Product Change Notice (PCN)

Subject: Change in test process for RH850/P1x, E1x, C1x, E2x series (alternative PKG Burn-in)

Publication Date: 7/25/2024

Description of Change:

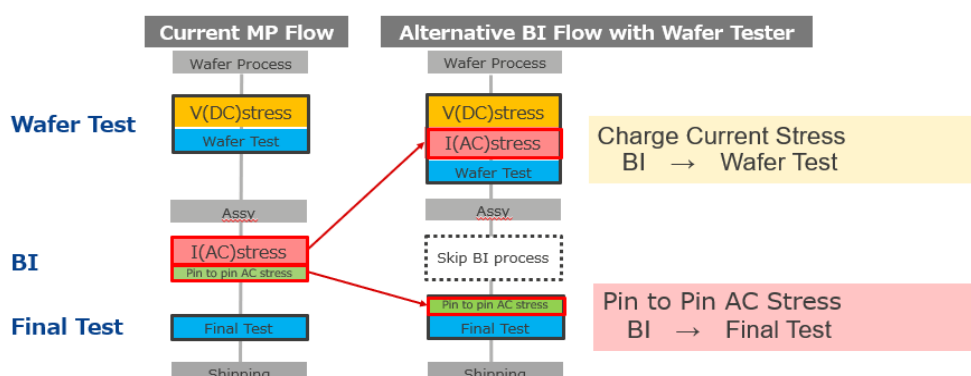
TEST PROCESS CHANGE (ALTERNATIVE BURN-IN)

This change replaces the stress test which checked out initial failures in Current BI Flow to Wafer Test and Final Test.
